MONTGOMERY COUNTY HISTORIC PRESERVATION COMMISSION
STAFF REPORT

Address:	11 Hesketh Street, Chevy Chase	Meeting Date:	10/25/2023
Resource:	Contributing Resource Chevy Chase Village Historic District	Report Date:	10/18/2023
Applicant:	Meredith & Gordon Griffin (Adele O’Dowd, Agent)	Public Notice:	10/11/2023
Review:	Historic Area Work Permit	Tax Credit:	n/a
Case Number:	1044886	Staff:	Dan Bruechert
Proposal:	Hardscape Alterations, new fencing, and deck alterations

Figure 2: Proposed fence and gate.

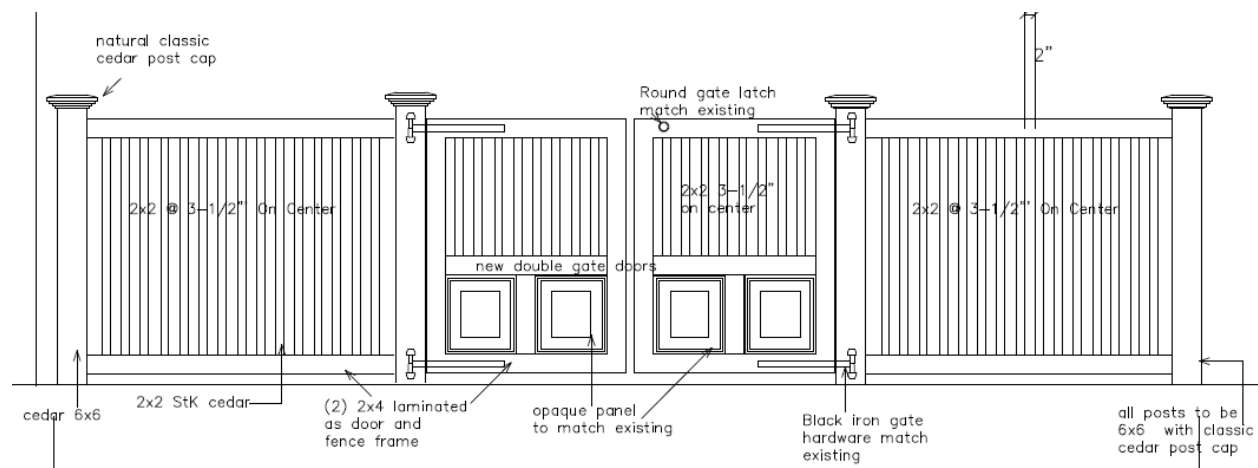
Staff finds the existing fence is not historic and its removal should be approved as a matter of course. The HPC typically limits fences forward of the historic rear wall plane to 48" (forty-eight) inches tall and requires an open picket design to retain the sense of openness found in the district. Staff finds the proposed fence satisfies that requirement and the fence will align with the existing fence installed at 9 Hesketh Street next door. Staff recommends the HPC approve the new fence and gate as consistent with the *Design Guidelines*, 24A-8(b)(2) and (d), and Standards 2, 9, and 10.
